Intel[®] 80303 and 80302 I/O Processors

Specification Update

May 6, 2003

Order Number: [273355-010](#)

2. Figure 9-3 on pg 9-9 did not print correctly

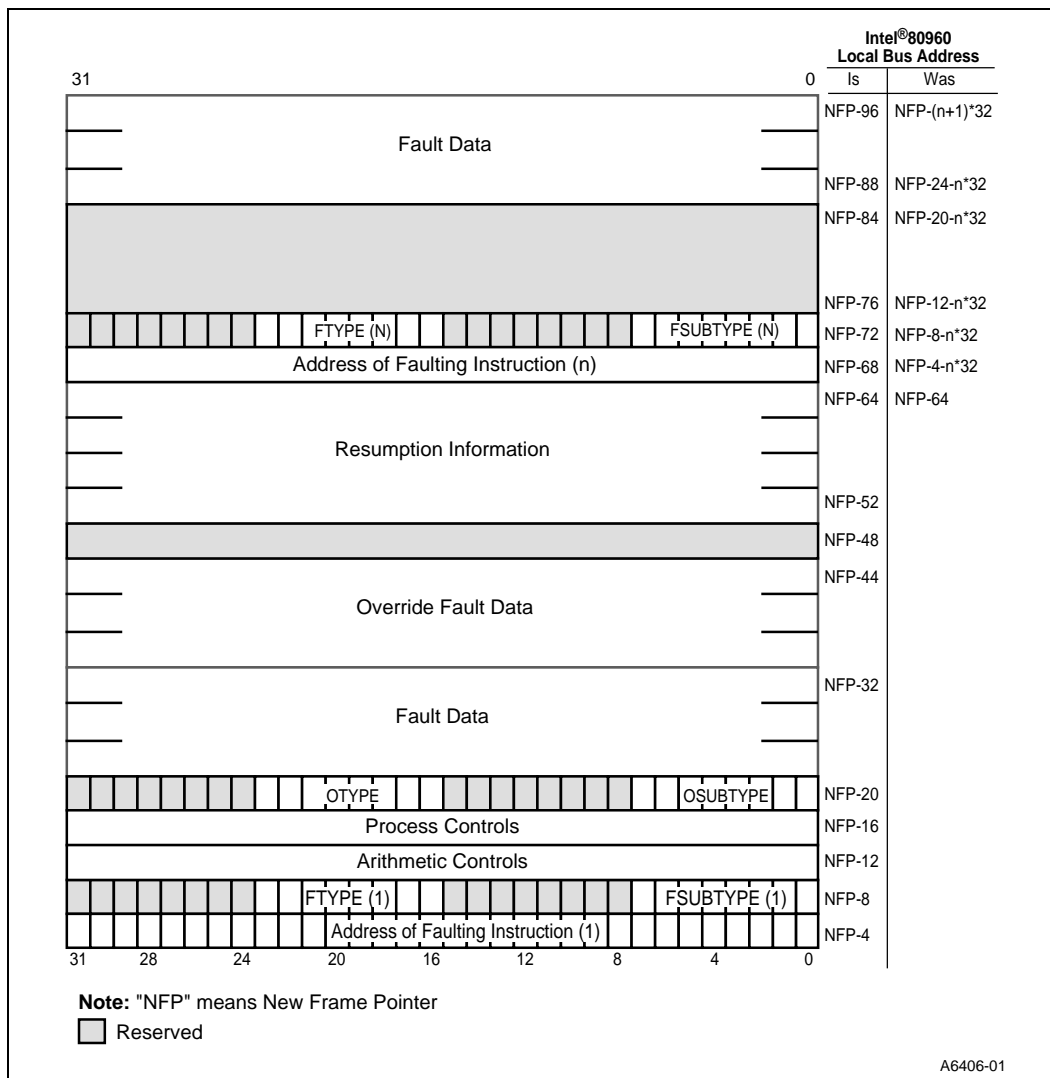
Problem: Figure 9-3 on pg 9-9 did not print correctly.

Workaround: Replace Figure 9-3 with the following:

3. Figure 13-22 on pg 13-40 did not print correctly

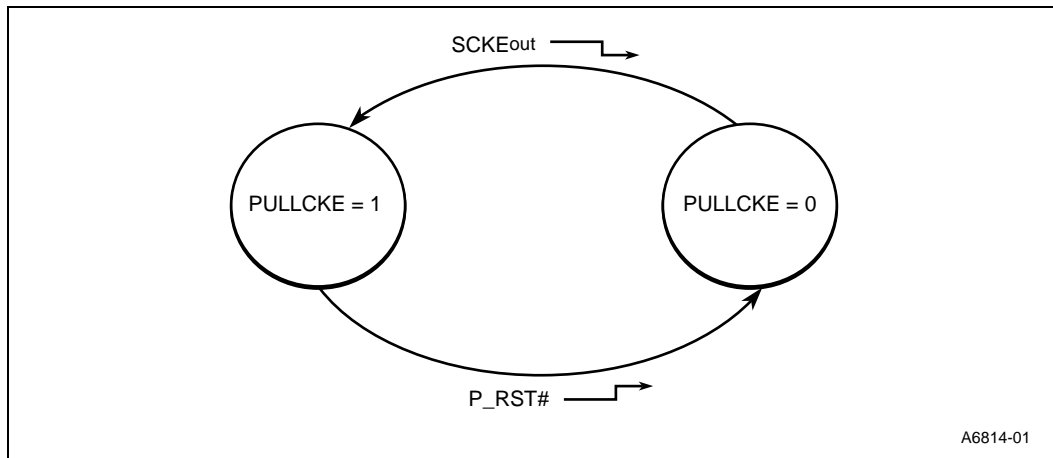
Problem: Figure 13-22 on pg 13-40 did not print correctly.

Workaround: Replace Figure 13-22 with the following:

5. **Figure 15-2 on pg 15-3 did not print correctly**

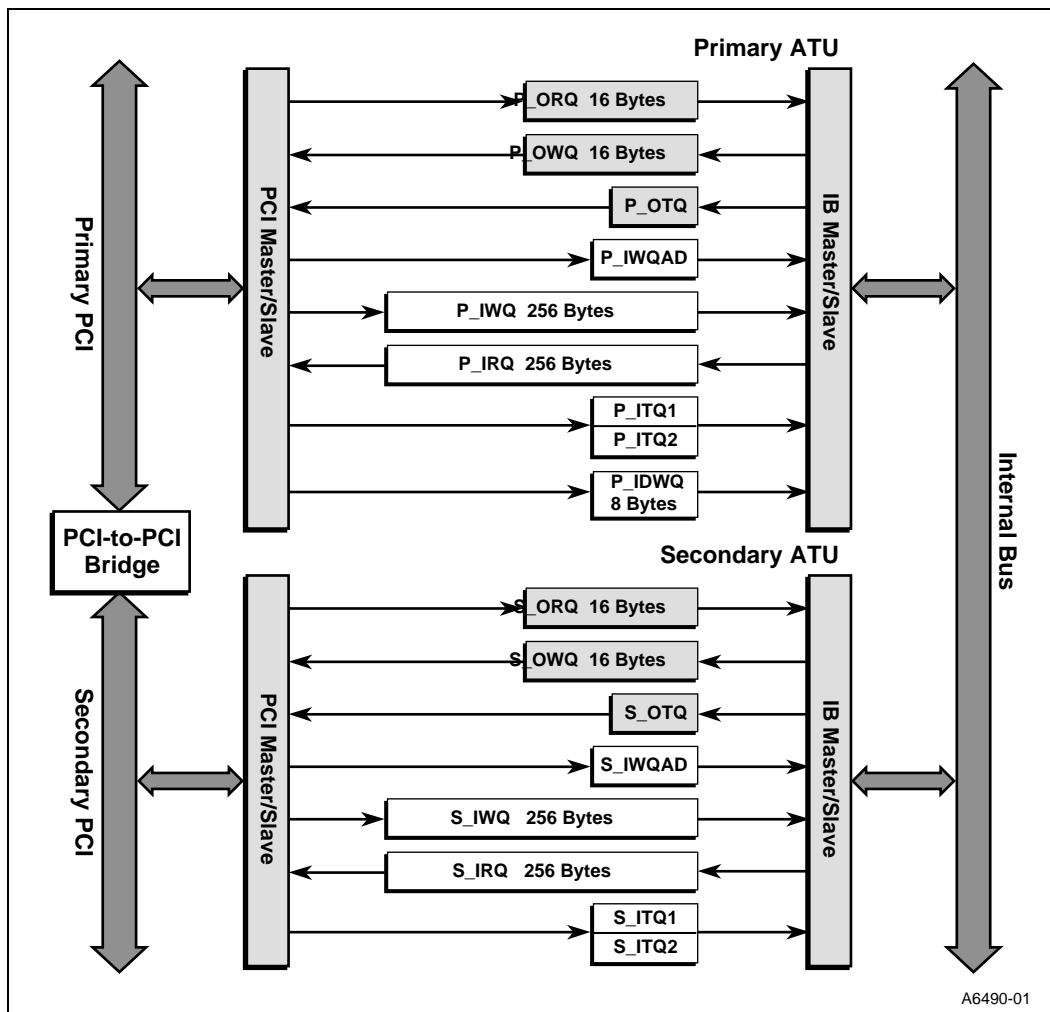
Problem: Figure 15-2 on pg 15-3 did not print correctly.

Workaround: Replace Figure 15-2 with the following:

Figure 25-1. Intel® 80303 I/O Processor Clocking Regions Diagram

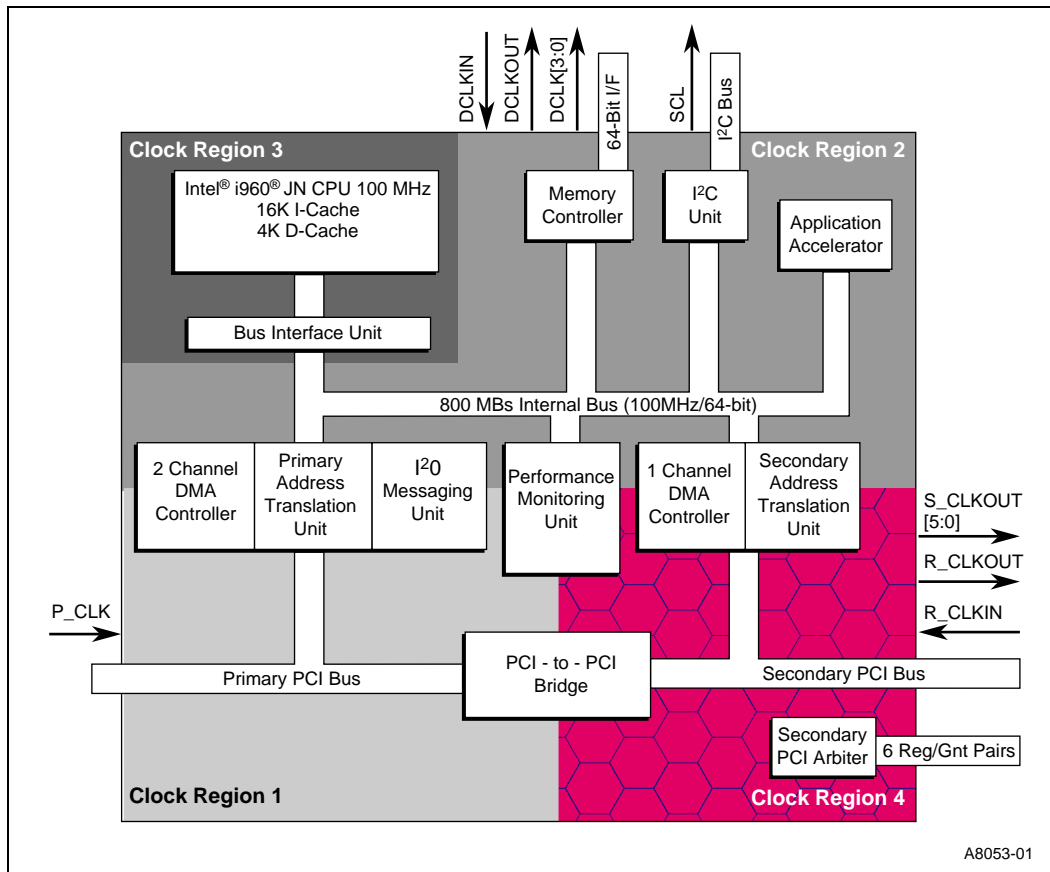
Problem: The Internal bus in diagram shows 66 MHz bus speed. The actual bus speed is 100 MHz

Workaround: Replace Figure 25-1 with the following:

11. Figure 25-2 on pg 25-2 did not print correctly

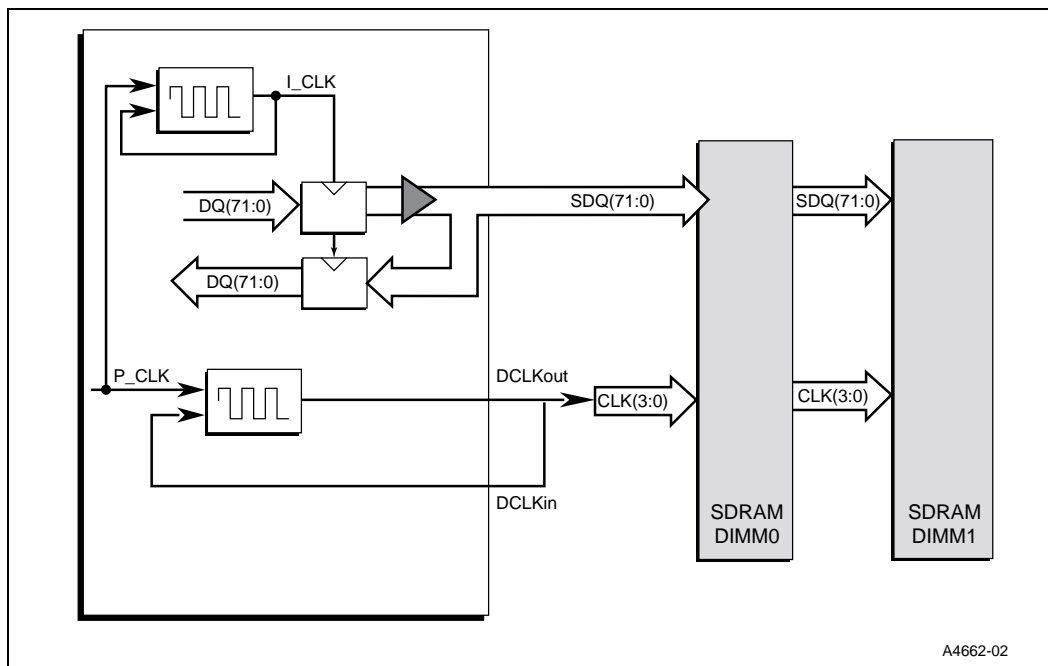
Problem: Figure 25-2 on pg 25-2 did not print correctly.

Workaround: Replace Figure 25-2 with the following:

Figure 12-2. Core Processor/BIU Interface Block Diagram

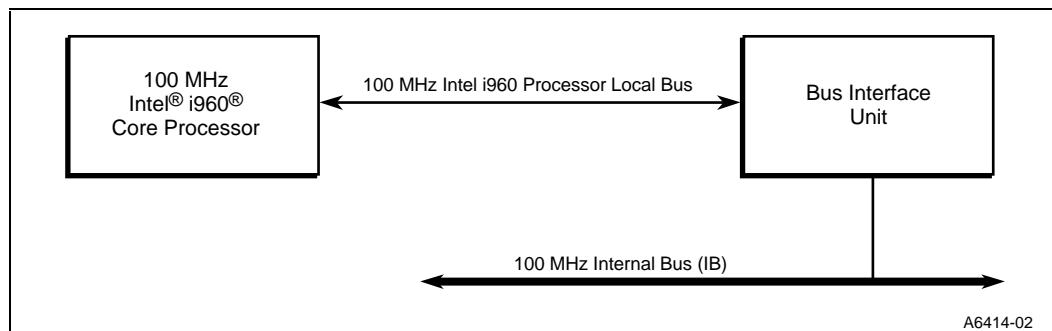
Problem: The Internal bus in diagram shows 66 MHz bus speed. The actual bus speed is 100 MHz

Workaround: Replace Figure 12-2 with the following:

18. Figure 15-3 on page 15-7 has missing text

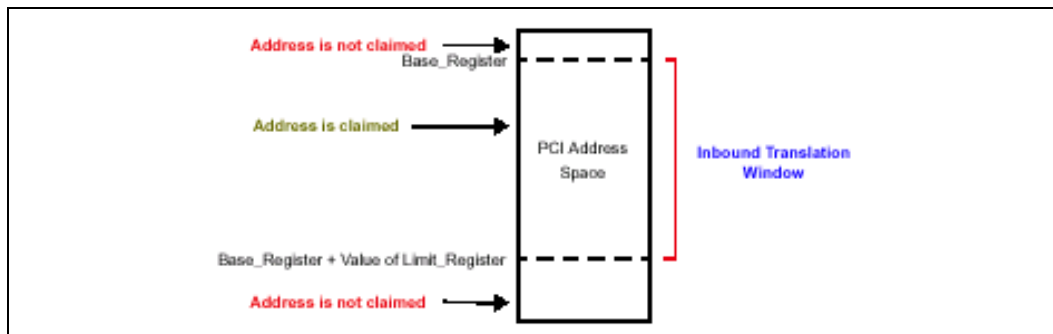
Problem: The figure shows 'se_Register + Value of Limit_Register'. It should be 'Base_Register + Value of Limit_Register'.

Workaround: Replace Figure 15-3 with the following:

Figure 13-16. ECC Read Data Flow

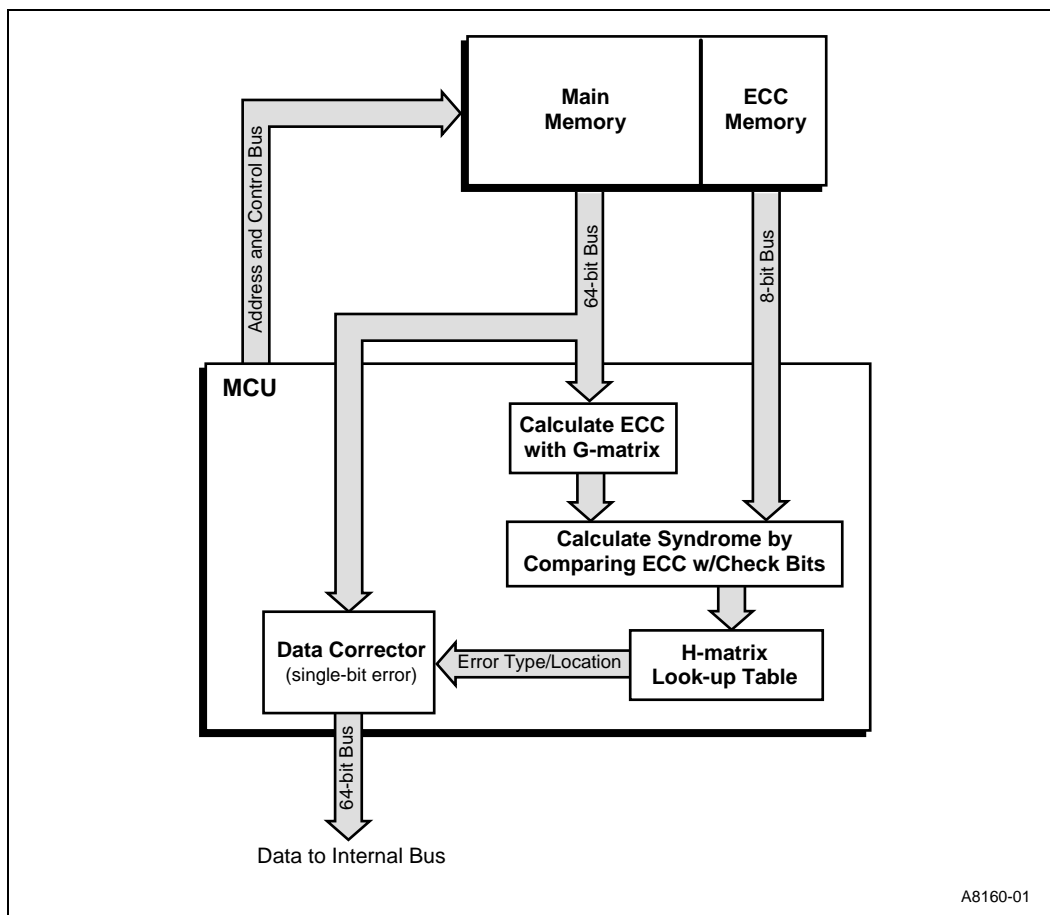
Figure 13-16 shows how the data flows through the ECC hardware for a read transaction.

Workaround: Replace Table 13-13 with the following and, add the adjacent paragraph with “new” Figure 13-16:
